Agenda
Subdivision & Development Appeal Board Hearing
June 23, at 1:00 p.m.
Town of Canmore Civic Centre Council Chambers

1. Call to Order (Chair)
2. Adoption of Agenda
3. Adoption of Minutes
None.
4. Appeal Hearing
PL20220286
634 7th Street
Lot 9, Block 71, Plan 1095F
Duplex with Two Accessory Dwelling Units
Appeal against a refusal by the Canmore Development Authority.
5. Other Business
None.
6. Adjournment

STAFF REPORT

DATE OF HEARING:	JUNE 23, 2023
PROPOSED DEVELOPMENT:	DUPLEX WITH ATTACHED ACCESSORY DWELLING UNITS
APPLICATION NUMBER:	PL20220286
LEGAL DESCRIPTION:	LOT 9, BLOCK 71, PLAN 1095F
CIVIC ADDRESS:	634 7 th STREET
CURRENT USE(S):	DETACHED DWELLING
APPLICANT:	VINCENT KOCH / STREETER DESIGN GROUP LTD.

Figure 1 – Impact of a 15m waterbody setback, from the McElhanney EIS

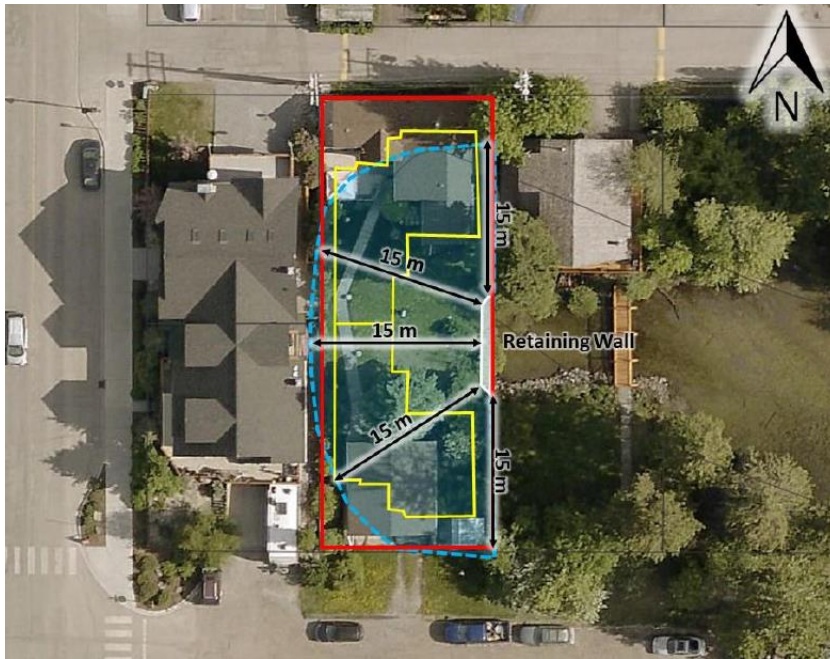
The waterbody setback is proposed at a minimum of 2.4m from the bank of Spring Creek, at its closest point (Refer to Attachment 4 – Site Plan). Section 2.5.1.2 of the Land Use Bylaw (LUB) requires a minimum 20m setback from all waterbodies, with a maximum 5m variance being within the Development Officer’s authority as per section 1.14.2 of the LUB.

The Planning Department supports this variance. As illustrated in the figure below, applying a 15m waterbody setback prohibits any redevelopment of this lot. Accordingly, the applicant has completed an EIS, which concluded that the redevelopment proposal would present low to negligible risk to environmentally sensitive features on the site. The recommendations contained within the EIS is included as conditions of approval (see attachment 5), to ensure Spring Creek is protected during and after redevelopment.

Figure 3 – side (east) elevation with the maximum envelope highlighted in red, and the variance highlighted in green. The bylaw maximum envelope (without the proposed setback variances) is overlaid in purple for comparison.

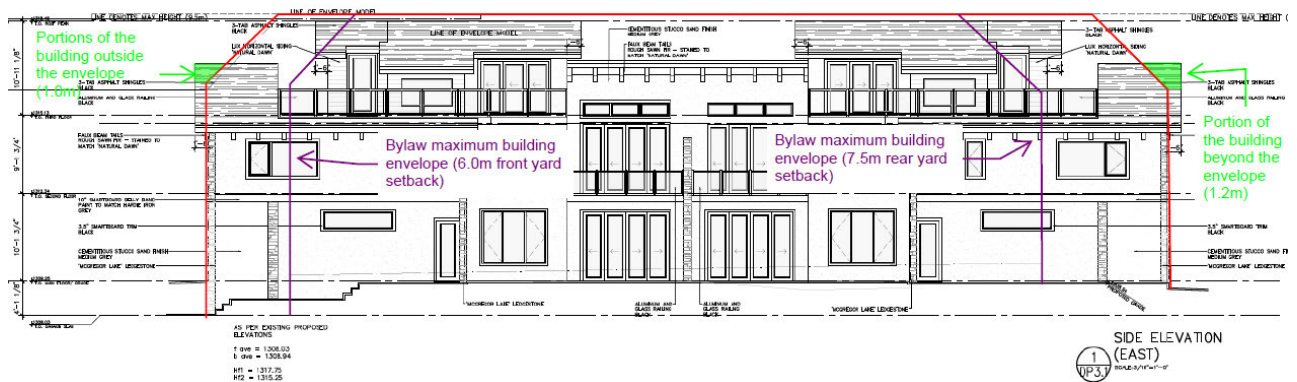
PLANNING DEPARTMENT POSITION

The Planning Department supports these variances. The building is under the maximum allowable height, and there are large portions of the maximum envelope that are not being utilized due to the waterbody present on site. In that context the proposed envelope variances are considered to be minor.
